SERVICE BULLETIN No. 11/09/2010

Check of Ripcord Handle Pins

MarS a.s., Okružní II. čp. 239, 569 43 Jevíčko
CZECH REPUBLIC

Pic. 1
Ripcord Handle U-064

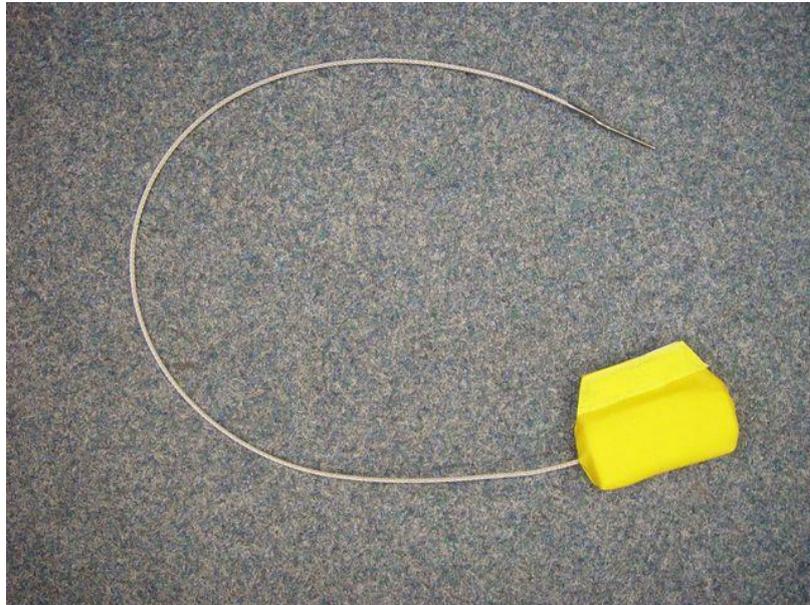
- 1. APPLIES TO:** the pins of ripcord handle reserve parachutes U – 064 (pic.1), U – 051 (pic.2) and U – 069 (pic.3), produced by Synek company (pressed pins – hexagonal press, see pic. 4 A - straight and pic. 4 B - bent), which are parts of:
Parachute sets Real – X, OP-103/ PS-034 S (U – 051)
OP-103/ PS-034 U (U – 064 or U – 051)
or OP-103/ PS-055 (U – 064),
Containers of parachutes with harness OP-087/ PS-034 S (U – 051)
OP-087/ PS-034 U (U – 064 or U – 051)
OP-087/ PS-034 UU (U – 064)
OP-093/01/ PS-034 S (U - 051),
and Parachute sets MarS – T, OP-095T/PS-052T(U – 069),
delivered by MarS a.s. Jevíčko, used in civil aviation,
and further
Parachute sets M 282 a M 291 (U - 051),
and Parachute sets PPSO CZ 330(HOP 330) (U – 069),
delivered by MarS a.s. Jevíčko, used in military aviation.

- 2. REASON:** During multiple tests for attestation of power for tearing off the ripcord handle it was found out gradual increase of the power beyond the permissible range that is defined by the regulation (22,2 to 97,9 N). During analysis of this situation it was found out that during the multiple tearing-off the ripcord handle the surface of the ripcord pin body can be damaged. This state can further cause an increase of power needed for tearing off the ripcord handle.

- 3. MEASURES:**
- A user or a packer licensed to pack the reserve parachutes (authorized person) proceeds a check of the ripcord handle pin at the products mentioned in part 1 and in case the pin body is found damaged, he/she puts the parachute set out of service.

- Further he/she sends a report with the type number of the ripcord handle and also the length of the ripcord handle at the type U-064 and U-051 to MarS a.s. Jevíčko to the fax number + 420 461 353 861 or to an E-mail mars@marsjev.cz.

- The producer sends the new ripcord handle to the user free of charge.
 - The user sends the original part of the ripcord handle back to the producer.
